Attorney Docket No. 48271-0001-00-US U.S. Appln. No. 10/708,950

Response to Office Action dated April 17, 2006

IN THE DRAWINGS:

Figure 1 (Prior Art)

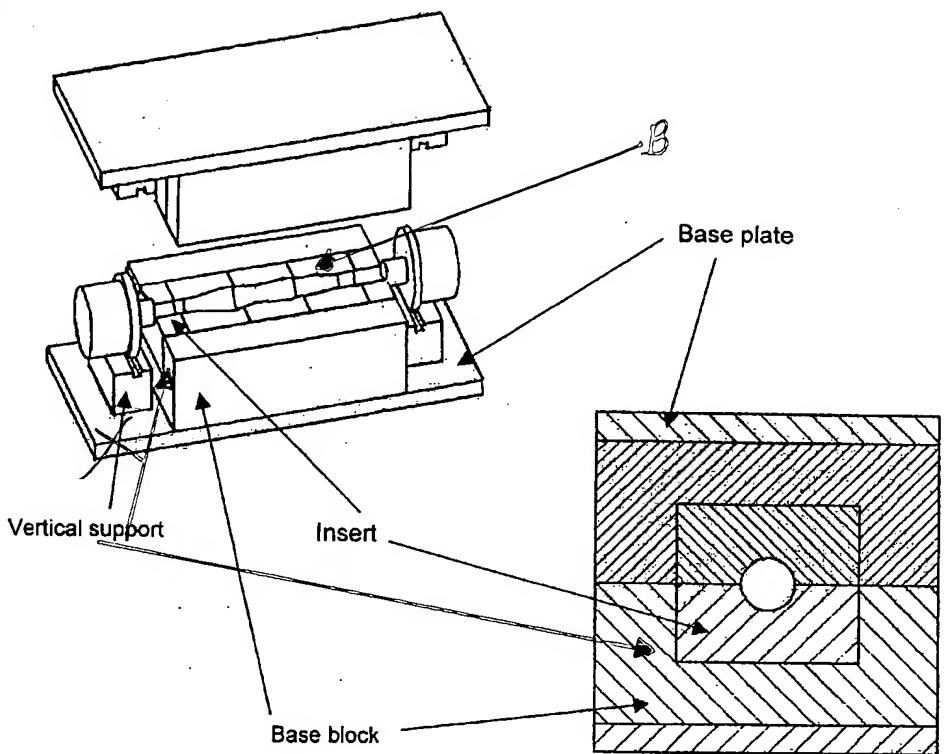
The attached sheet of drawings include changes to the figures. In particular, Figure 1 has

been amended to correctly reference the vertical supports. In addition, reference character B has

been added the figure. With regard to Figure 2, the Y and Z axis have been interchanged to correctly

Figure 2

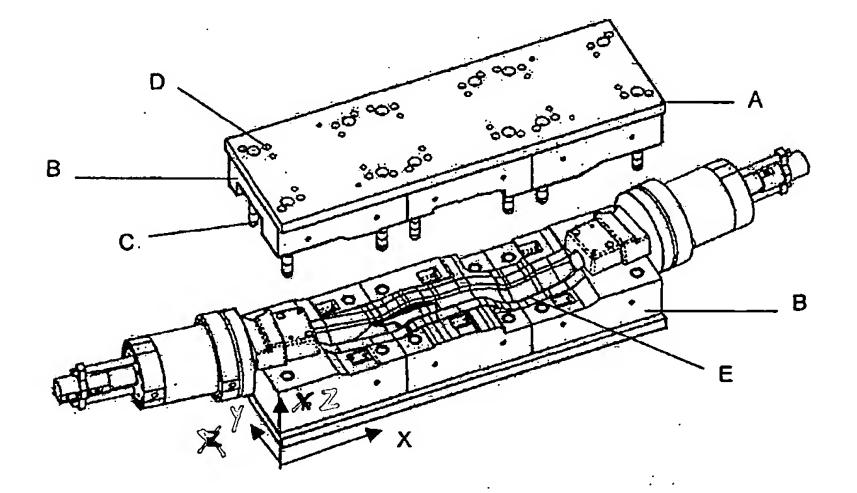
denote the 3 axes.
